No. RW/BNG/PER.CASES/BJP. DVN/2015/1400

Notice Inviting Public Comments on proposal seeking permission for laying of Lift irrigation scheme raising main (MS) across NH - 548B (Vijayapura - Sankeshwar section) at Km 129.084 & 133.284 in the State of Karnataka by Minor Irrigation and Ground Water Development Department, Division Belagavi -Reg.

Sub:- Permission for laying of Lift Irrigation Scheme Raising main (MS) along NH-548B (Vijayapura Sankeshwar section) and 2 nos. crossings at km 129.084 & 133.284 for a total length of 15.200 km in the State of Karnataka - Reg.

LEGEND	
SHEET NO	01
Road Width	
Bridge/Culvert	
Median Center	
NH BOUNDARY/ROW

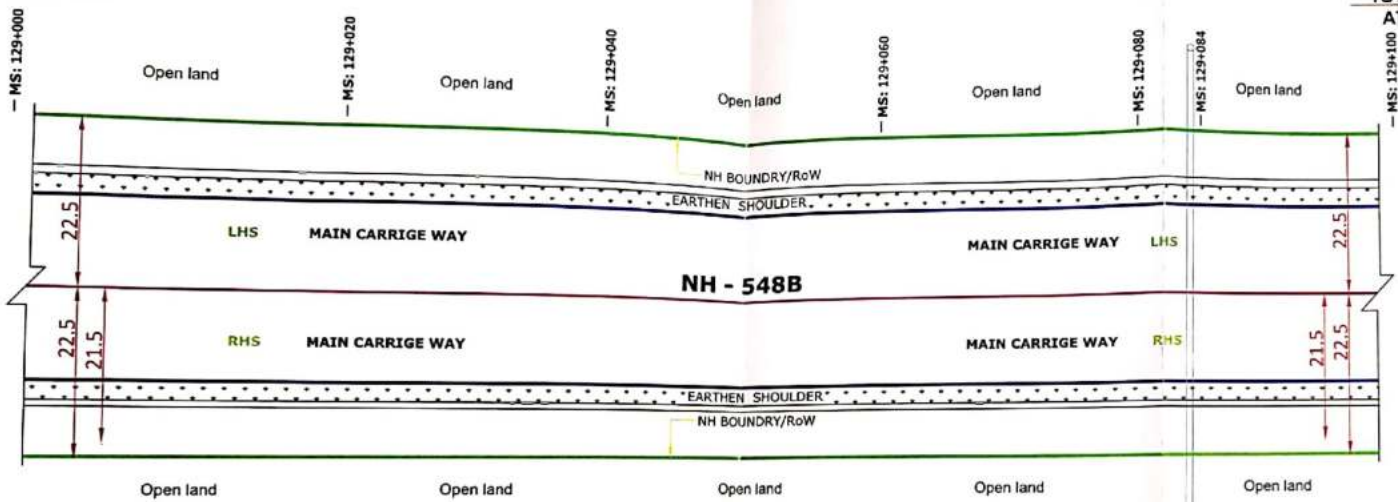
4	As per the drawing enclosed with the proposal, it is observed that, the proposed pipeline is crossing the NH at angle. The utility services shall cross the National Highway preferably on a line normal to it or as nearly so as practicable.	As per the enclosure copy.
5	The methodology of laying of pipeline along and across the National Highway is not specified.	Open trench Methodology cross section enclosed.
6	The license fee calculation & performance bank guarantee calculation as per Ministry's circular dtd: 22.11.2016 needs to be submitted. Supporting documents in respect of area rate issued by the competent authority need also to be submitted.	Verified.
